# Access Compliance Report

## Public Rights-of-Way

Intersection ID: 14071	Main Street: CLEVELAND_AV	Cross Street: E_KINGSTON_AV	Location: W
ADA ID: FA44B96719E3	Ramp Type: Perp	Initial Pass/Fail: Fail	Overall Compliance: No
Severity Score: 21.25			
Codes/Mitigation Info/Possible Solution		Field Measurements/Component Compliance

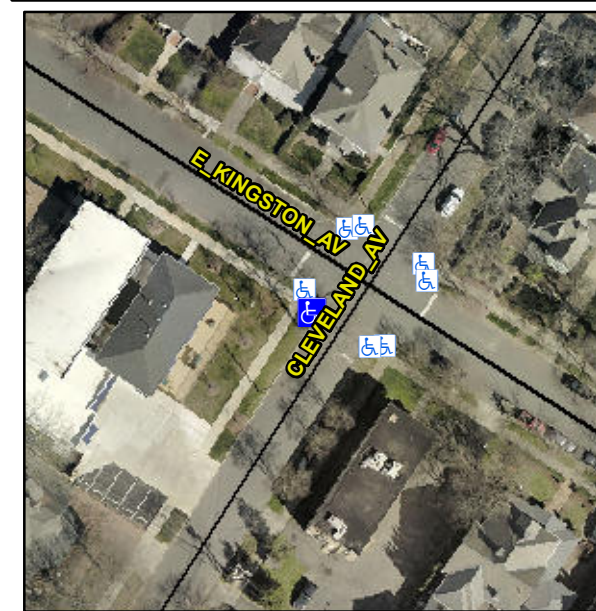
**R304.5.1, R304.5.3**

Compliance	Description	Data	Compliance	Description	Data
N/A	Ramp Length (in)	53.0	Yes	Ramp Slope (%)	7.4
No	Ramp Width (in)	36.0	No	Ramp XSlope (%)	5.1
N/A	Flare Type LT	N/A	N/A	Flare Type RT	N/A
N/A	Flare Slope LT (%)	N/A	N/A	Flare Slope RT (%)	N/A
N/A	Flare Traversable LT?	N/A	N/A	Flare Traversable RT?	N/A
N/A	Landing Length (in)	N/A	N/A	DWS Provided?	N/A
N/A	Landing Width (in)	N/A	N/A	DWS Contrast?	N/A
N/A	Landing Slope (%)	N/A	N/A	DWS Length (in)	N/A
N/A	Landing X Slope (%)	N/A	N/A	DWS Full Width?	N/A
N/A	Landing Curb? (Y/N)	N/A	N/A	DWS Offset (in)	N/A
N/A	Shared Landing?	N/A			
N/A	Gutter Ponding?	N/A	N/A	Gutter Slope (%)	N/A
N/A	Gutter Lip Ht (in)	1.0	N/A	Gutter X Slope (%)	N/A
N/A	Painted X Walk1?	No	N/A	Painted X Walk2?	N/A
	X Walk 1 Direction	To SE		X Walk 2 Direction	N/A
N/A	X Walk 1 Width (in)	N/A	N/A	X Walk 2 Width (in)	N/A
	X Walk 1 Slope (%)	4.3		X Walk 2 Slope (%)	N/A
	X Walk 1 X Slope (%)	0.1		X Walk 2 X Slope (%)	N/A

**Remove & Replace Entire Ramp.**
